DRC
Staff Report

Case:	11662 / Related Case: 9153
Project Name:	Waterhurst Plaza
Location:	5911 S. Watterson Trail
Owner(s):	Sylvia Hunt
Applicant:	Neal Campbell
Representative:	Bardenwerper/Talbott/Roberts, PLLC
Project Size/Area:	6.3 acres
Jurisdiction:	Louisville Metro
Council District:	22 – Robin Engel
Zoning District:	C-N
Form District:	Neighborhood
Request:	Revised Detailed District Development Plan
Case Manager:	Mike Wilcher, Planner II

- Approval of a Revised Detailed District Development Plan to permit construction of a 36,550 square foot retail center on the subject site.

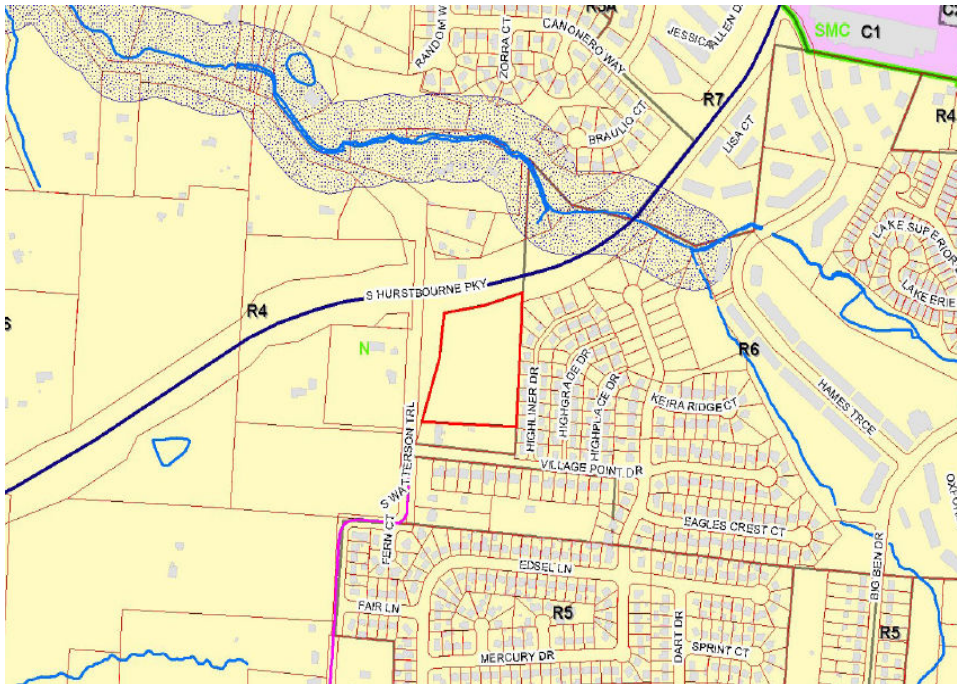
- Entrance on S. Hurstbourne Parkway changed to right in / right out only
- Elimination of parking lot adjacent to Hurstbourne Parkway in the northeast corner of the site
- Elimination of a drive-thru lane from the 14,700 square foot retail structure
- Division of the 14,700 square foot retail structure into two structures
- Addition of a focal point with a fountain in front of the plaza dining area
- Conversion of the rear plaza dining area to a landscaped pavilion with direct accessibility to the adjacent neighborhood
- Elimination of a sidewalk across a parking lot to be replaced with landscaping and a tree lined sidewalk connecting the structures
- Addition of a central landscaped plaza with benches in the parking area
- Addition of a sidewalk along S. Watterson Trail to Village Point Drive
- A stub for future crossover access to property south of the subject site
